April 2, 2019

**New Lithia Park Horseshoe Pit Structure**

EXHIBIT A

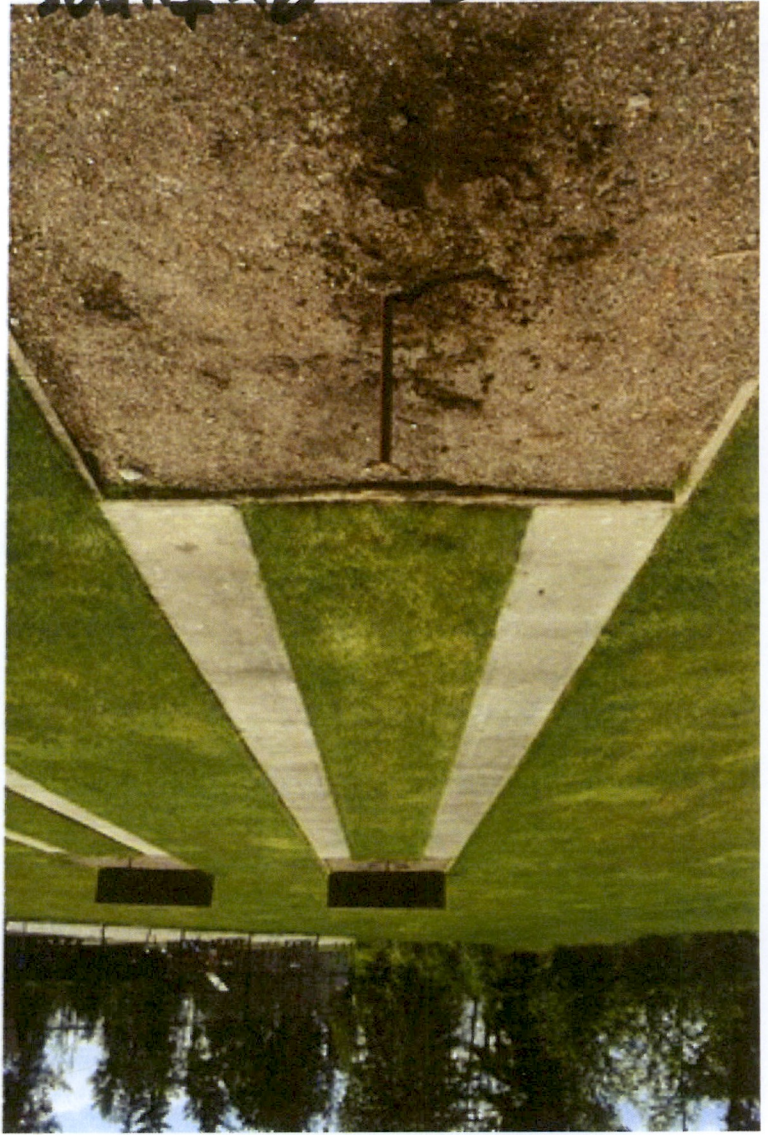
My name is Bruno Marcotulli. I am a resident of Ashland. I'm here because I believe the newly reconstructed horseshoe pit area in Lithia Park is dangerous, and should be rebuilt to its original dimensions, or eliminated altogether.

I believe there is now a very real danger of someone, particularly someone older, being injured while swinging a heavy horseshoe some 24 feet. Such effort requires balance, and such balance requires the room to twist, move & heave. The problem is that the backstop is now too close to the stake, as are the two sides of this new boxed area. This confined space makes it very easy to imagine someone falling backward over the backboard, or tripping over the 4 inch high side-borders, and impaling themselves on the stake.

The new **Lithia Park horseshoe pit structure's** dimensions are **two feet shorter from side to side**, and **two feet shorter from backboard to stake**, than those shown in the submitted diagram.

"Horseshoe pits vary widely in dimensions and features as you can see in the attached photos. The Eagle Scout working on this project made measurements and built the pits to acceptable standards with the materials they had available. It is important to exercise caution when playing horseshoes in general due to the nature of the game and it seems reasonably safe the way it is set up."

EXHIBIT C

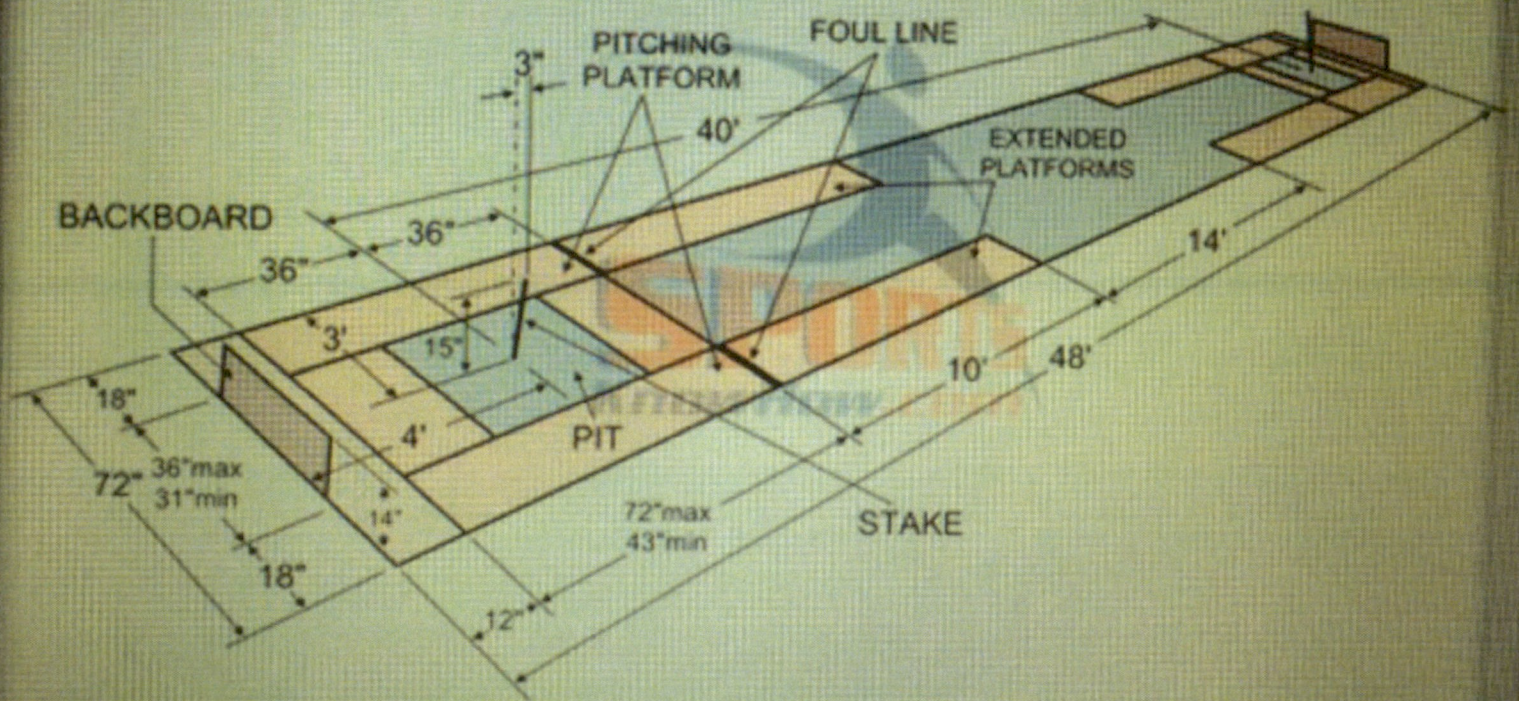
\* I have submitted a diagram of an appropriately sized horseshoe pit area.
